工程指示 / 要求簡箋(E.I.)

工程指示編號：EI / 7032 / 23

工程名稱：將軍澳日出康城 11

工程項目：(特色層) 後裝 FD 門 廠用 鐵件 共 12 件 跟 12 號門窗圖

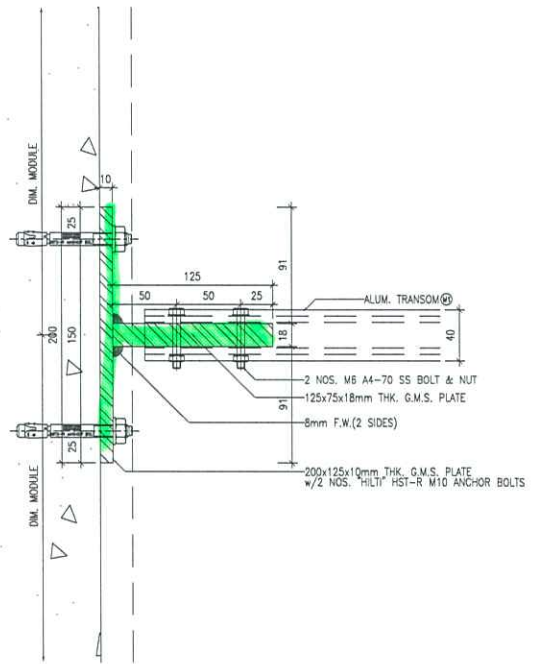
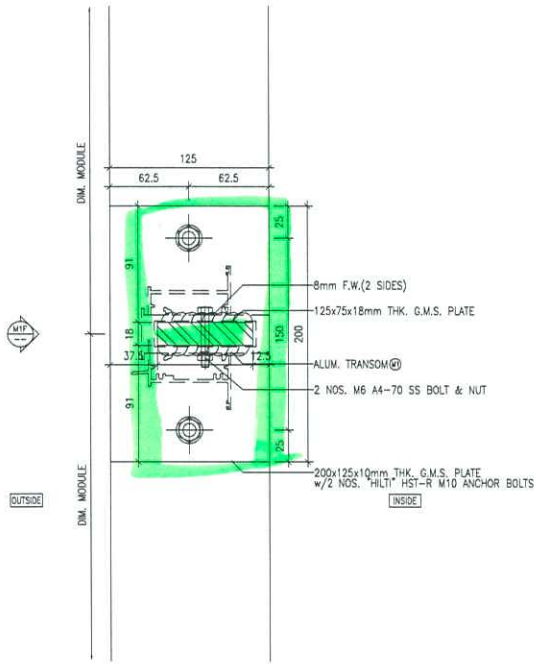
Detail 6006
5004

修
146螺絲

修M10

各備2件。
分裝 打整

共12個

A 版：鐵件改送廠組裝。

請按加工圖生產，送地盤安裝。(FD 門用)

1. 需要 驗焊 (100% visual, 10% MPI) For Curtain Wall
2. 出貨前，請給 Mill Cert 和熱浸 Cert
3. 沿水油厚度 符合 EI5136 指示 100um
4. 需油瀝青油
5. 分座打扎
6. 跟 F.D 門 / 梗門 (頂底) 5004a 及 F.D 門加百葉 (左右) 6006a 圖紙

1 VERTICAL DETAIL
6006 SIDE FIXING DETAIL FOR M1

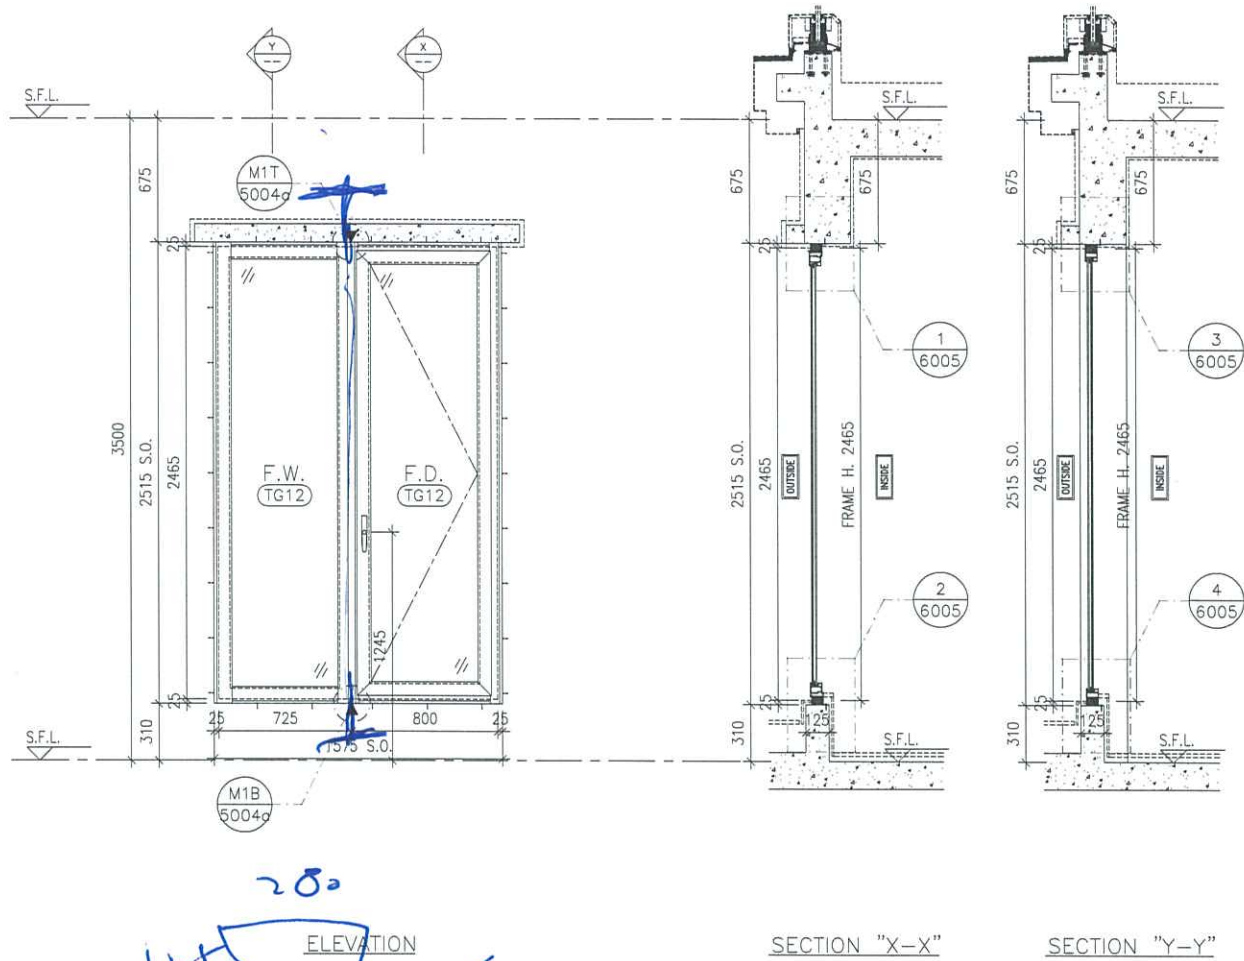
F.O.P. 用

下. 6月 24日 等 (左右)
